Access Compliance Report Public Rights-of-Way (Curb Ramps)

Intersection ID: N/AMain Street:PINEVILLE-MATTHEWS_RDCross Street: N/ANALocation:NEADA ID: 22ABA7CEB382Ramp Type:PerpDiagInitial Pass/Fail:FailOverall Compliance: NoSeverity Score:22.5

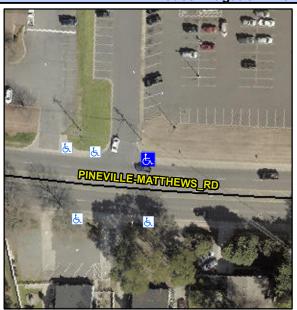
OSSIBIC OCIULION
Possible Solutions:
Remove & Replace Curb Ramp With Two New Directional Ramps or Equivalent.
Surveyor Notes: N/A
PROW/ADA:
Not Found, R304.5.1, R304.2.2, R304.5.3

Field Measurements/Component Compliance						
Compliance Description		Data	Comp	liance Description	Data	
N/A	Ramp Length (in)	62.0	No	Ramp Slope (%)	10.3	
No	Ramp Width (in)	40.0	No	Ramp XSlope (%)	3.7	
N/A	Flare Type LT	N/A	N/A	Flare Type RT	N/A	
N/A	Flare Slope LT (%)	N/A	N/A	Flare Slope RT (%)	N/A	
N/A	Flare Traversable LT?	N/A	N/A	Flare Traversable RT?	N/A	
N/A	Landing Length (in)	N/A	N/A	DWS Provided?	N/A	
N/A	Landing Width (in)	N/A	N/A	DWS Contrast?	N/A	
N/A	Landing Slope (%)	N/A	N/A	DWS Length (in)	N/A	
N/A	Landing X Slope (%)	N/A	N/A	DWS Full Width?	N/A	
N/A	Landing Curb? (Y/N)	N/A	N/A	DWS Offset (in)	N/A	
N/A	Shared Landing?	N/A				
N/A	Gutter Ponding?	N/A	N/A	Gutter Slope (%)	N/A	
N/A	Gutter Lip Ht (in)	N/A	N/A	Gutter X Slope (%)	N/A	
N/A	Painted X Walk1?	No	N/A	Painted X Walk2?	No	
	X Walk 1 Direction	To W		X Walk 2 Direction	To S	
N/A	X Walk 1 Width (in)	N/A	N/A	X Walk 2 Width (in)	N/A	
	X Walk 1 Slope (%)	0.5		X Walk 2 Slope (%)	2.9

X Walk 1 X Slope (%)	1.8		X Walk 2 X Slope (%)	4.1	
N/A	Ramp inside XWalk1?	N/A	N/A	Ramp inside XWalk2?	N/A	
	Road Slope (%)	0.9	N/A	Clear Space?	N/A	
	Road X Slope (%)	1.3	N/A	Clear Space to XWalk (in)	N/A	
N/A	Any Obstructions?	N/A	N/A	Storm Grate/Utility Hazard?	N/A	
	Obstruction Type			Storm Grate/Utility Type		
		N/A			N/A	
			Yes	Surface Condition? (G/P)	Good
